# Fire Protection and Water Supply Plan Addendum 1 Lot 1 DP 109606 Princes Highway, Frogs Hollow

30 April 2018

Project No. S-518

The purpose of this addendum to the Fire Protection and Water Supply Plan is to provide additional information requested by Bega Valley Shire Council (BVSC).

**Figure 1** shows the components of the fire supply system.

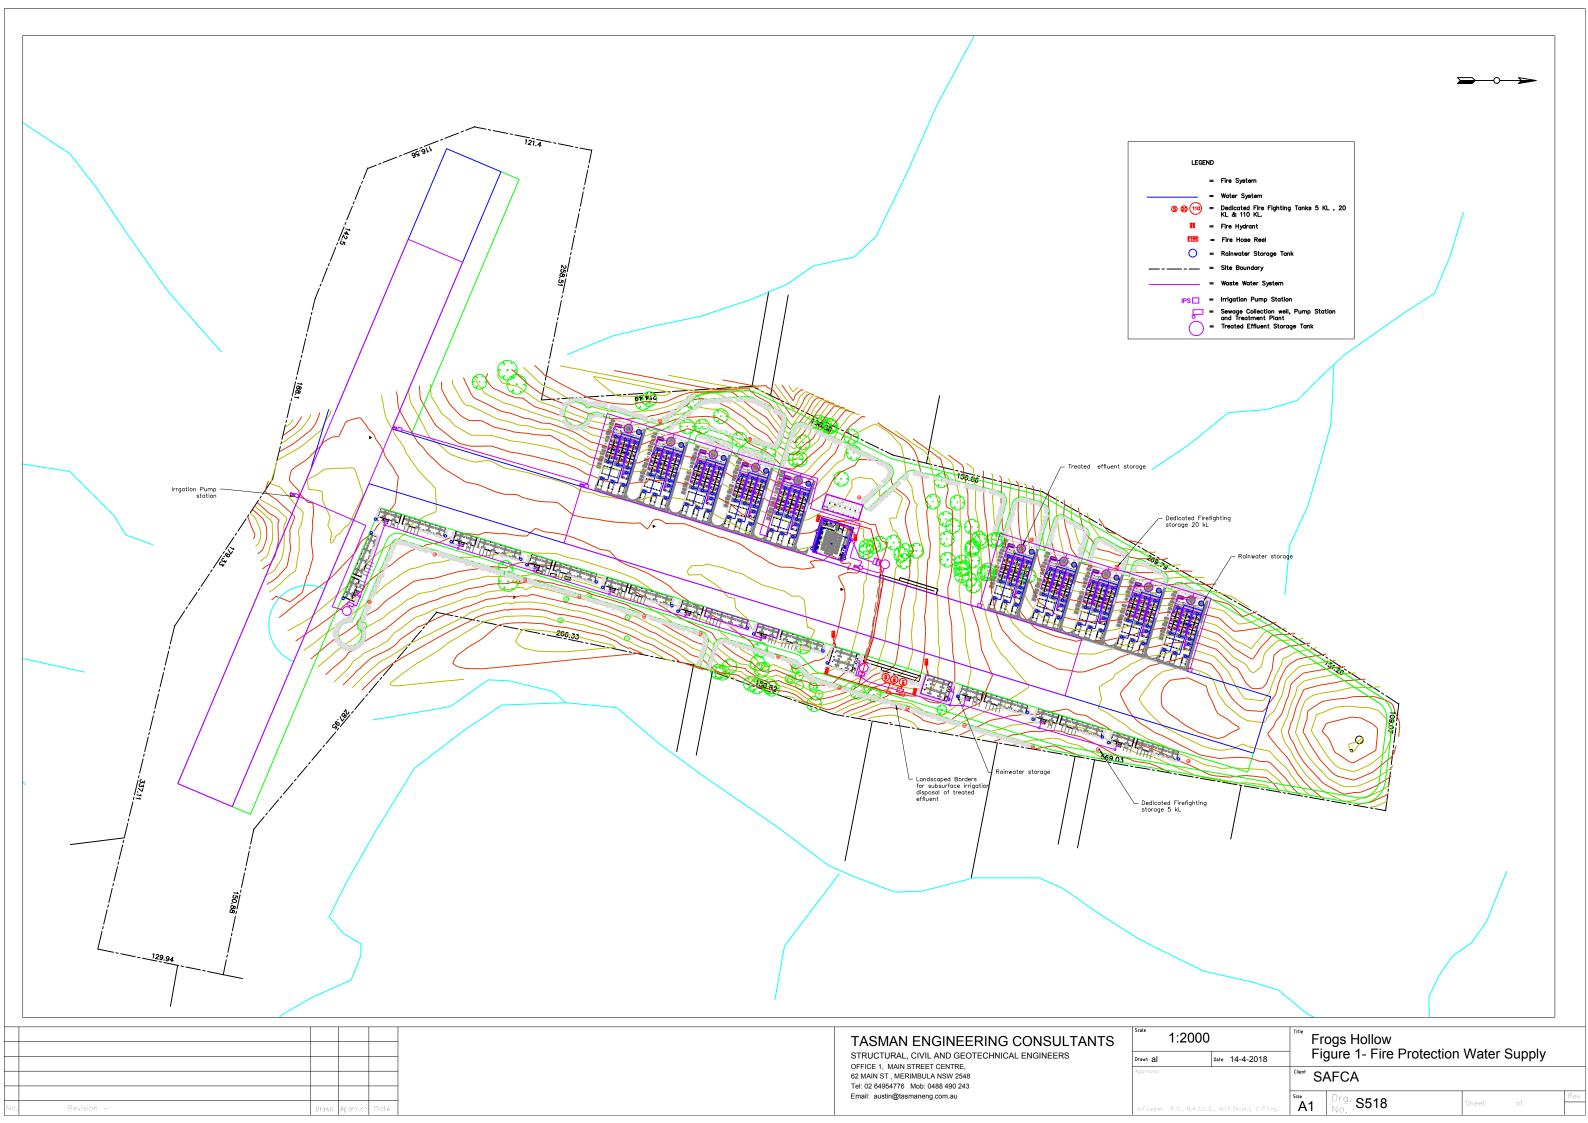
Specifically BVSC has requested the following in relation to fire and potable water supply:

- Information regarding systems for making potable water,
- Preliminary hydraulic assessment for a fire suppression system to insure compliance with NSRF condition 4 of RFS letter dated 11 Dec 2017.

The fire suppression system is intended to be supplied by on site treated effluent which is stored in dedicated above ground tanks. RFS has indicated that the system must comply with:

- Two hydrants shall be provided to service each of the Maintenance Buildings as well as the Main Building and Parking Area.
- The Main Building and Workshop Buildings and Car Park also shall be protected by a fire hose reel system to serve all parts of the buildings.

- The pressure and flow requirements are specified as 10 l/s per hydrant at a dynamic pressure of 700 KPa.
- A dual pump set is required and would operate at the design flow of 20 l/s and design pressure of 700 kPa + head loss.

- A AS 2419 compliant booster assembly is required and can be supplied off the shelf.
- A 330 KL water supply is specified in three 110 KL tanks. An additional 150 Kl would be available from
  the stand alone fire water storage tanks at various locations around the site and would provide for the
  required 50% 24 hour refill volume specified in AS 2419.1-2005.

- Tanks shall have a tank gauge which is visible from the area of the booster assembly.
- The final design would also include an analysis of the piped distribution system to ensure that the
  pressure and flow requirements are achieved. This includes adjusting the pipe size to achieve the
  pressure and head loss within the required specification of 150 KPa maximum head loss and a
  maximum static pressure of 1300 KPa.

- Underground piping shall consist of PN 16 UPVC bell and spigot pipe.
- All above ground piping including hydrant stand pipes shall be steel.
- Trenching details and details of thrust blocks and pipe restraints would be shown in detail in the final design documentation.
